Traffic and Transportation

In accordance with the MEPA Scope, this chapter directly responds to agency and public review comments within MEPA jurisdiction. Copies of the Secretary's Certificate on the Draft Environmental Impact Report (DEIR) and each comment letter received during the public review period of the DEIR are included in this chapter. This chapter provides responses to those letters.

Table 6-2 Response to Comments

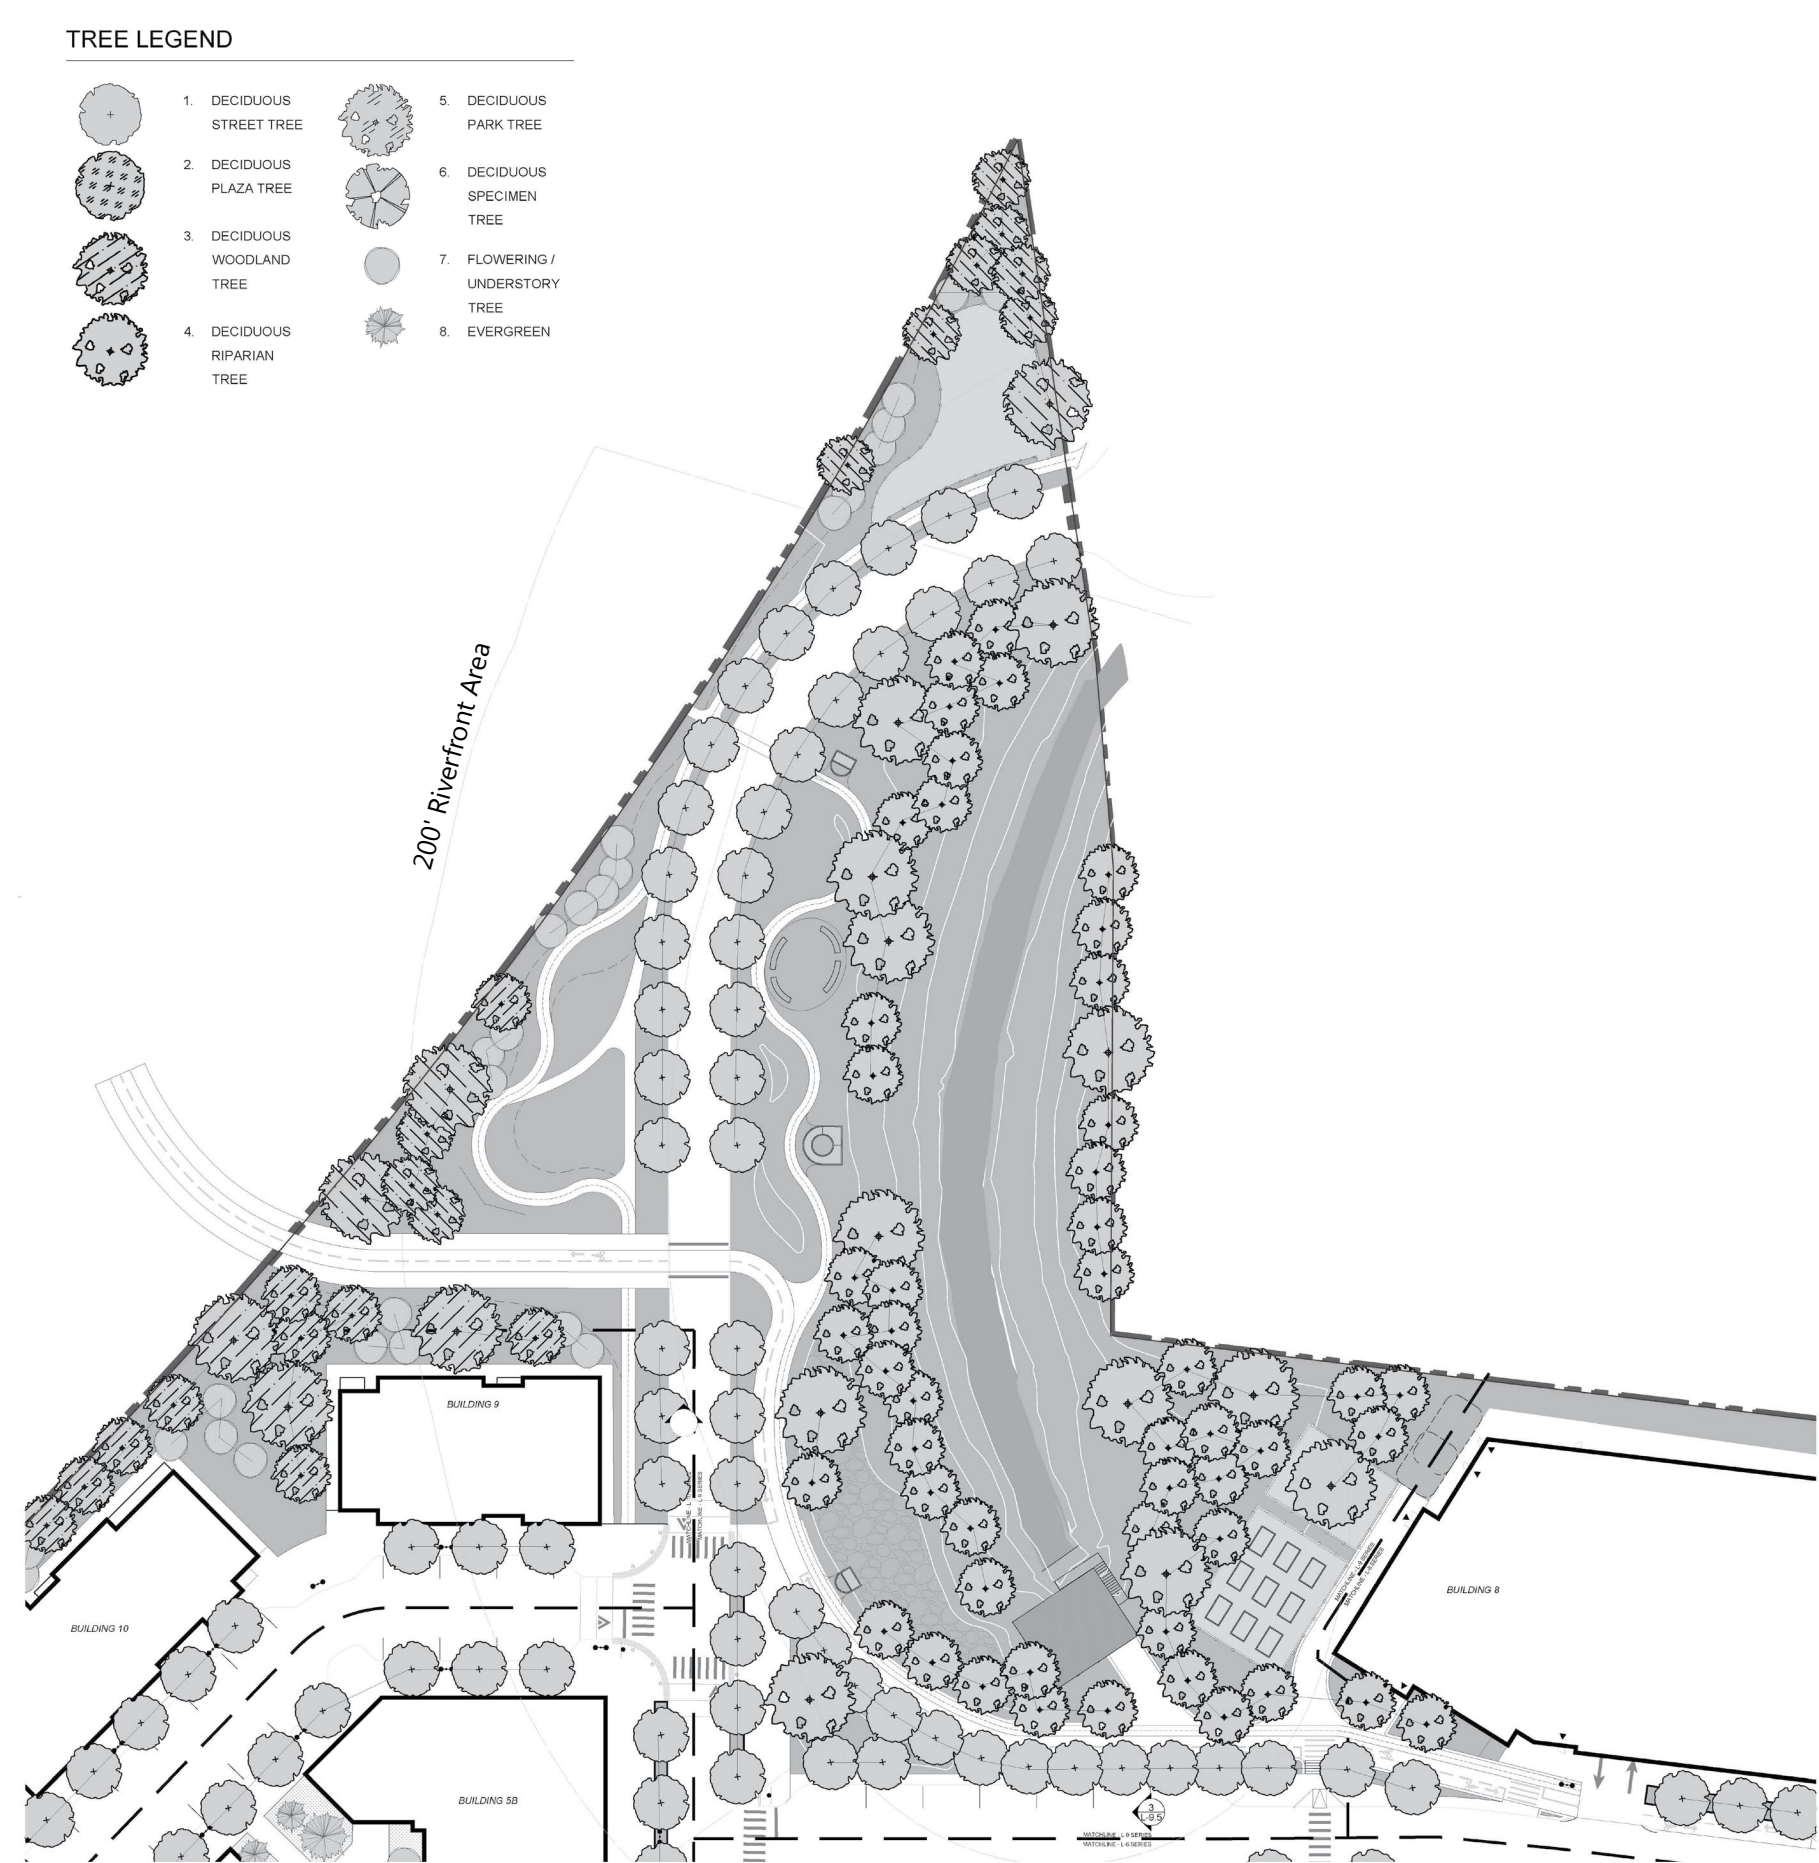
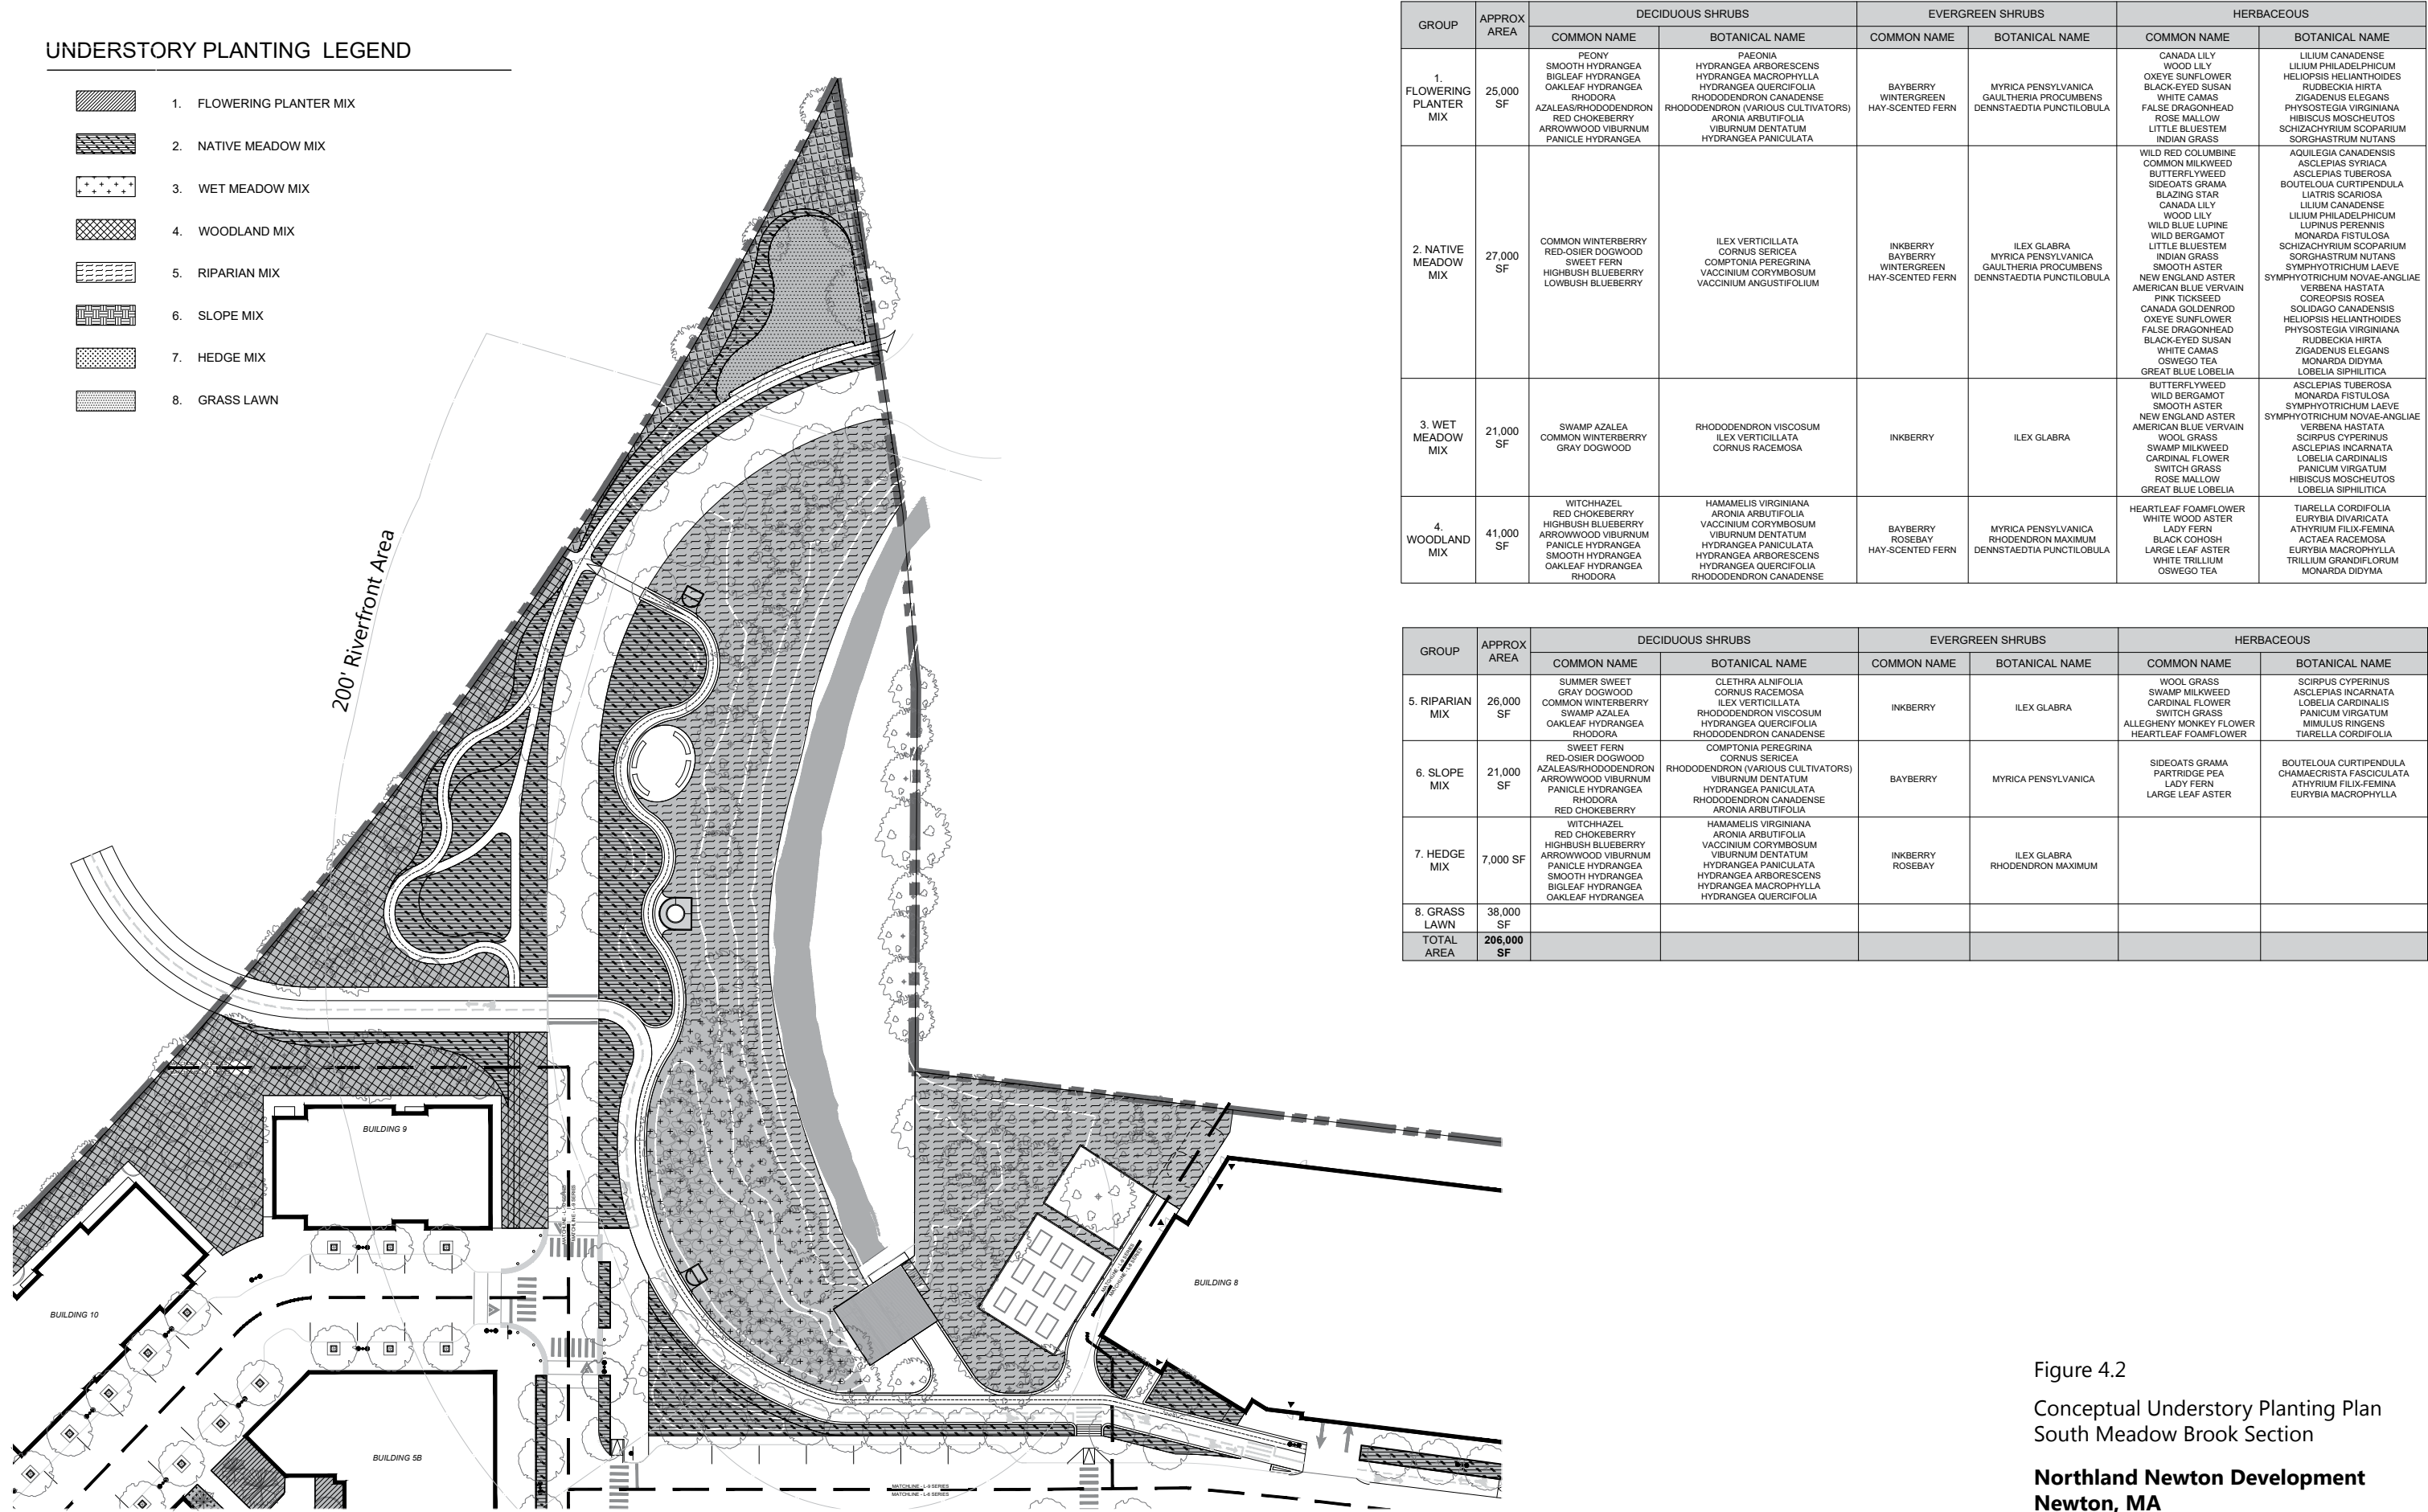
1.35	The FEIR should provide a plan clearly showing all project components within the Riverfront Area, quantify potential impacts to all wetland resource areas and floodplain and describe mitigation measures.	Figures 4.1 - 4.4h provide information on the plantings proposed for the Project and work within the existing daylighted section of South Meadow Brook. No work is proposed within Land Under Waterbodies and Waterways. Refer to Section 4.1 of Chapter 4, <i>Wetlands</i> for more details.

Comment #	Commenter	Comment	Response
5.04 CRWA	<p>Finally, given that the project includes work proposed in the 200 ft. Riverfront Area (RA) of the daylighted section of the South Meadow Brook, the FEIR should contain more details regarding the nature of the work. While the Proponent has committed to improving the RA by reducing the area of pavement and by planting a diverse selection of native trees, shrubs, and other plants, the FEIR should include a much more comprehensive stream restoration plan and supporting details.</p>		<p>Section 4.1 of Chapter 4, <i>Wetlands</i> includes a description the restoration of elements of the South Meadow Brook Riverfront Area. Figures 4.1 - 4.4h provide information on the plantings proposed for the Project and work within the existing daylighted section of South Meadow Brook.</p>
